# Access Compliance Report

## Public Rights-of-Way

Intersection ID: 12646	Main Street: LEVINE AVENUE OF THE ARTS	Cross Street: S TRYON ST	Location: E
ADA ID: 8114C9FAE72B	Ramp Type: Perp	Initial Pass/Fail: Pass	Overall Compliance: No
Severity Score: 10.25			
Codes/Mitigation Info/Possible Solution		Field Measurements/Component Compliance

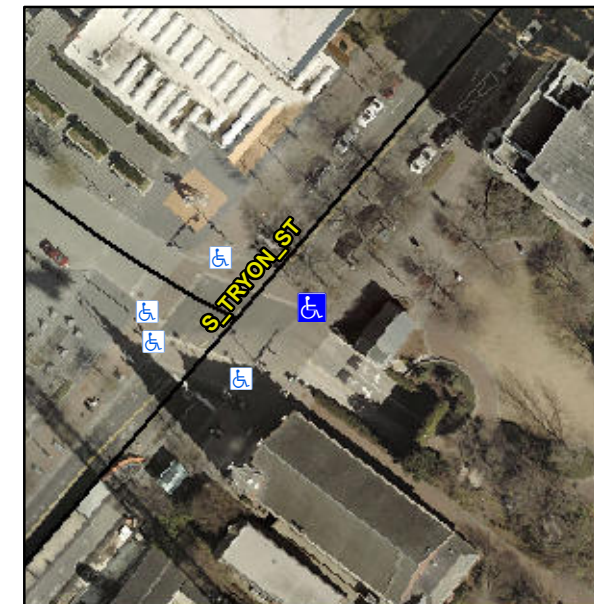
**Remove & Replace Entire Ramp.  
Remove & Replace Gutter.**

**R304.5.3, R304.2.3, R305.1.4,  
R304.5.4**
